RE: SigSauer License and SSD, Point of sale packaging label

Please accept this letter as a request for amendment to SigSauer's license 28-35454-01E and SSD NR-1487-D-101-E.

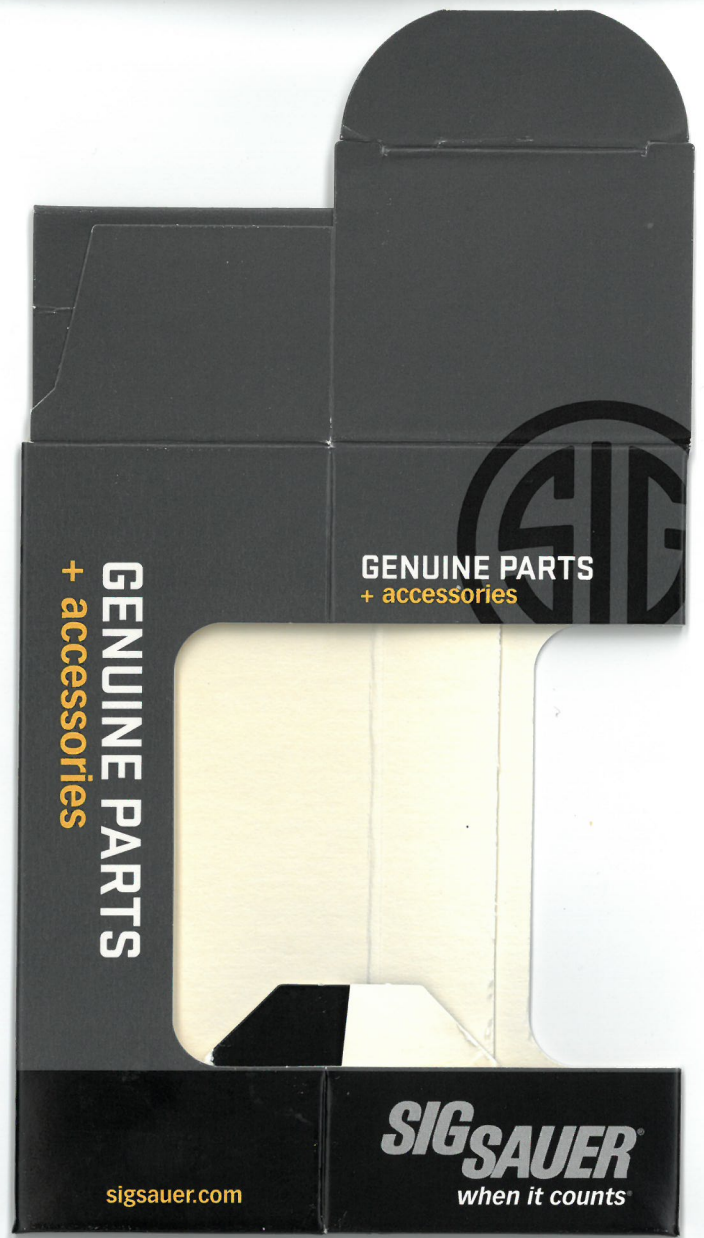
In Sig's initial application for SSD and license, Sig provided a point of sale package label that provides more information than is required for self-luminous devices. This label requires additional labor for its placement on the package.

Sig's current packaging already contains Sig's name as the manufacturer or distributor and Sig's website address, as required by 10 CFR 32.25. An example of this packaging is included with this letter. Therefore Sig is requesting that the NRC recognizes that the packaging meets the requirements of 10 CFR 32.25 and that the additional labeling submitted with the initial application, is no longer required.
